AD-1

Model: AD1 (DF43)		Date: 28-Feb-97	No: 019	1/2
Subject: Black stripes			Prepared by: K. Ugaeri	
From: QAC 2nd Field Information Dept .			Checked by: S. Fujii <i>T. Inoue</i>	
Classification:	<input checked="" type="checkbox"/> Troubleshooting <input type="checkbox"/> Mechanical <input type="checkbox"/> Paper path <input type="checkbox"/> Other ()	<input type="checkbox"/> Part information <input type="checkbox"/> Electrical <input type="checkbox"/> Transmit/receive	<input type="checkbox"/> Action required <input type="checkbox"/> Service manual revision <input type="checkbox"/> Retrofit information

Model: AD1 (DF43)		Date: 28-Feb-97	No: 022	1/1
Subject: Front Guide Plate and Rear Guide Plate			Prepared by: Horiike	
From: QAC 2nd Field Information Dept .			Checked by: S. Fujii	
Classification:	<input type="checkbox"/> Troubleshooting	<input checked="" type="checkbox"/> Part information	<input type="checkbox"/> Action required	
	<input type="checkbox"/> Mechanical	<input type="checkbox"/> Electrical	<input type="checkbox"/> Service manual revision	
	<input type="checkbox"/> Paper path	<input type="checkbox"/> Transmit/receive	<input type="checkbox"/> Retrofit information	
	<inp

Fig.1

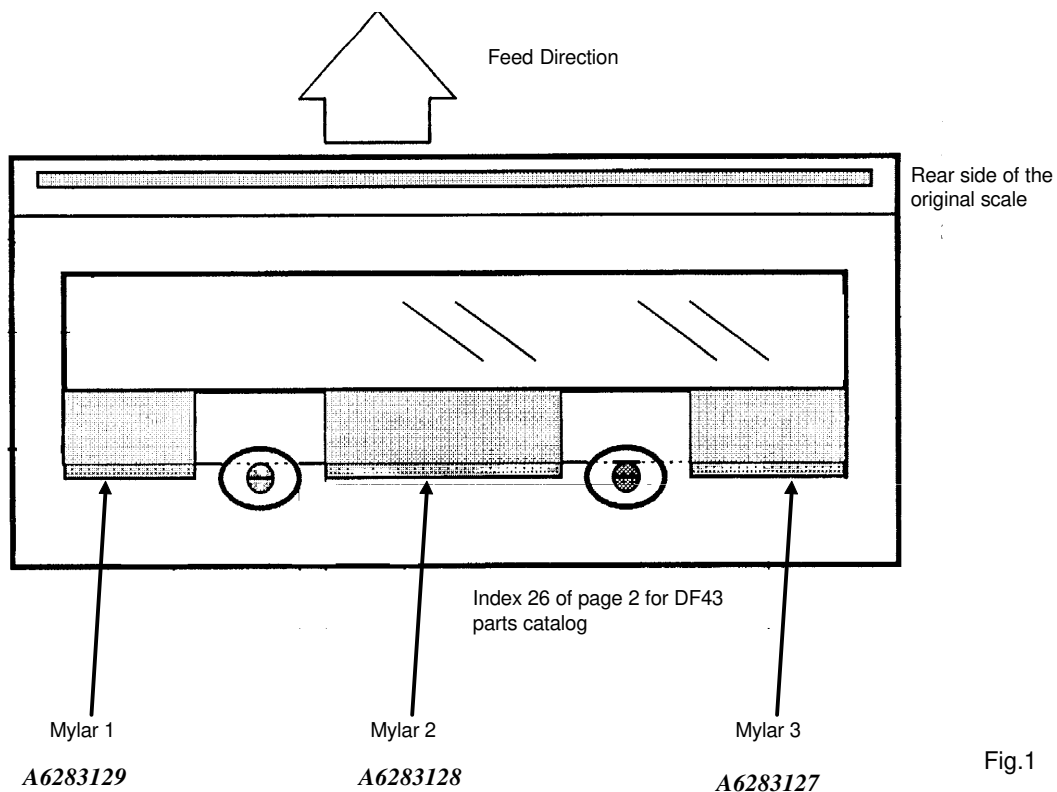
Black stripes when using the sheet scanner

Dust on the exposure glass.

1. The **three** mylars have been added on the original scale (A6283192) to prevent the scanning position on the exposure glass from becoming dirty.

Fig. 2

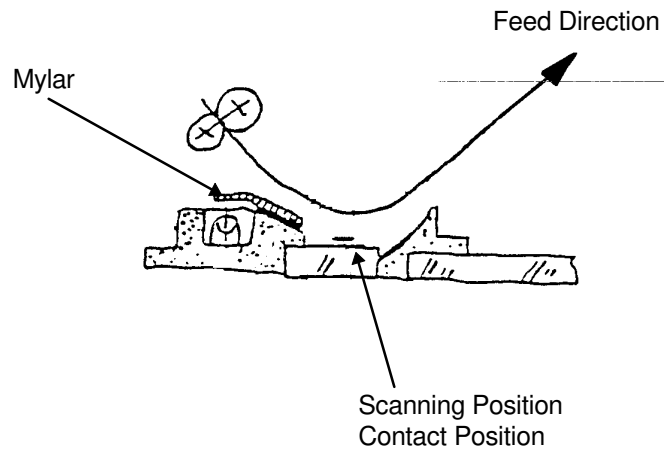
Because the contact position of the original becomes dirty with paper dust, it has been moved from the scanning position by using mylars.

Fig. 3

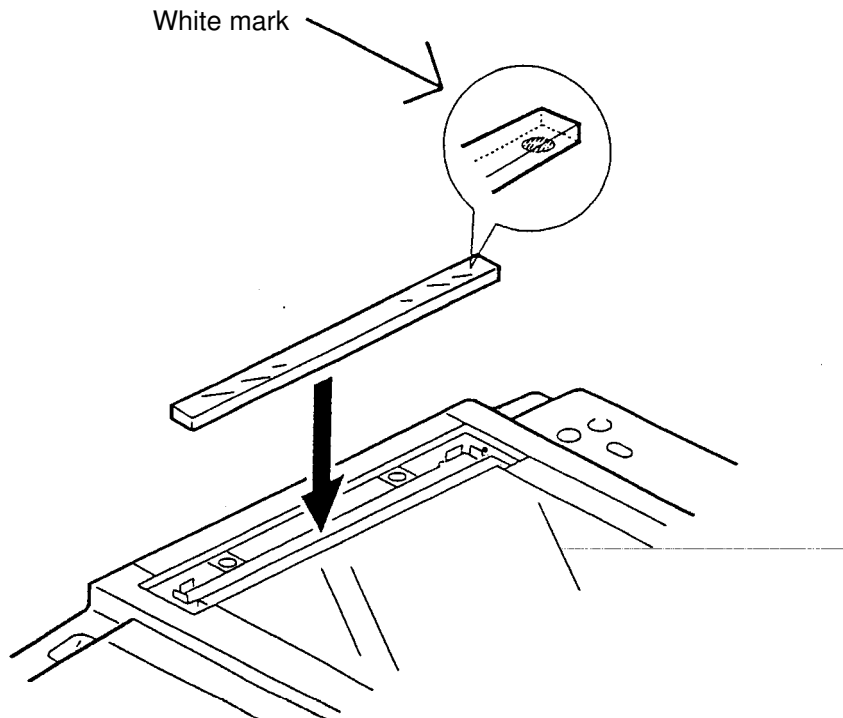
2. The surface of the exposure glass has been treated by the mater replant process.

Note: This exposure glass has a white mark. This mark must be at the bottom rear side at installation.

Current	New
Front Guide Plate	A628 1218B	A628 1218C
Rear Guide Plate	A628 1219B	A628 1219C

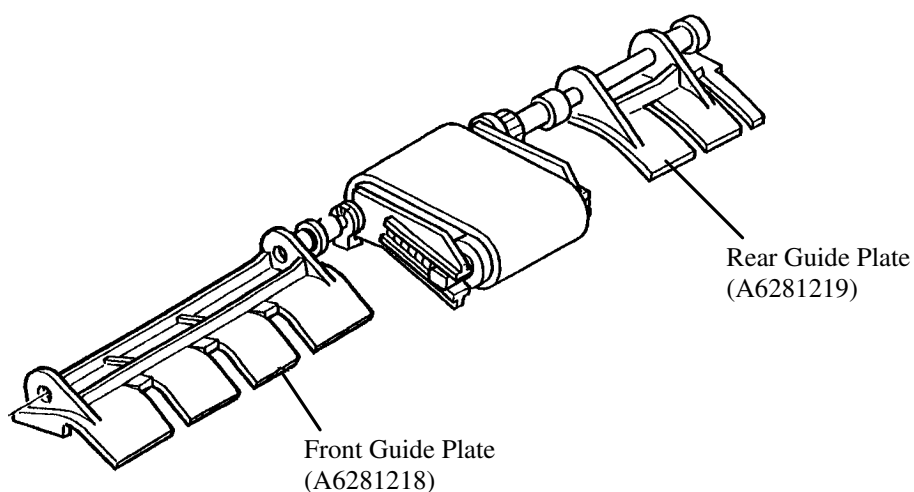
The left cover cannot be closed.

The Front or Rear Guide Plate was accidentally turned to the left when the operator removed a jammed original, because these plates are difficult to see.

The color of the Front and Rear Guide Plates has been changed from black to a clear color.

[Jam Removal Decal] A628 6031B → A6286031C

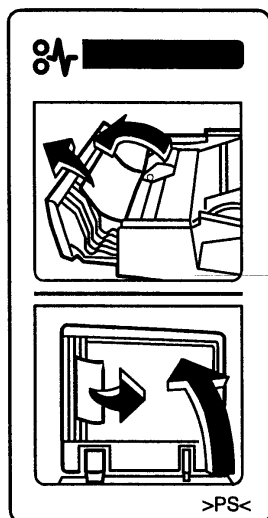
To make the removal procedure for a jammed original easier to understand, the drawing on the decal has been changed
